RE: AFIN: 72-00828 Permit No.: 4747-WR-1

## NO DISCHARGE INDUSTRIAL PERMIT INSPECTION FORM

Response to Inspection

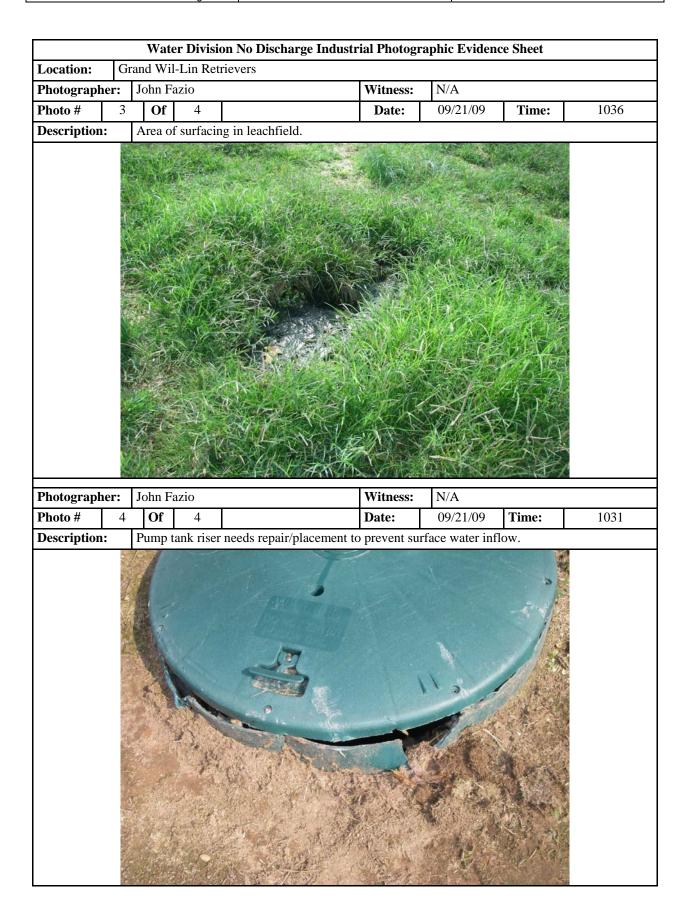
- 1. Wastewater is surfacing in the leachfield. This is in violation of Part 1, Condition 2 of your permit. This condition must be corrected immediately. Heavy machinery had driven over the leachfield and may have caused damage to one or more of the field lines.

1. S			the inspection: lue to damage from heavy i	nachinery.			
Repa	ir or replacement of	f the pump tank riser was r	ecommended.				
The f	facility is otherwise	well operated and maintai	ned. The kennel and groun	ds are very clean.			
Ms. I repai		e is going to investigate the	e cause of the surfacing, and	d make the necessary			
Inspe	ector Signature:	Joh Taj	Date of Report:	09/28/09			
Signa	ature of Reviewer:	Dale D. Washer	Date of Review:	September 28,2009

Dear Mr. Anderson;
Please be advised that the work has been completed by the contractor. we are now in compliance with the requirements of the permit.
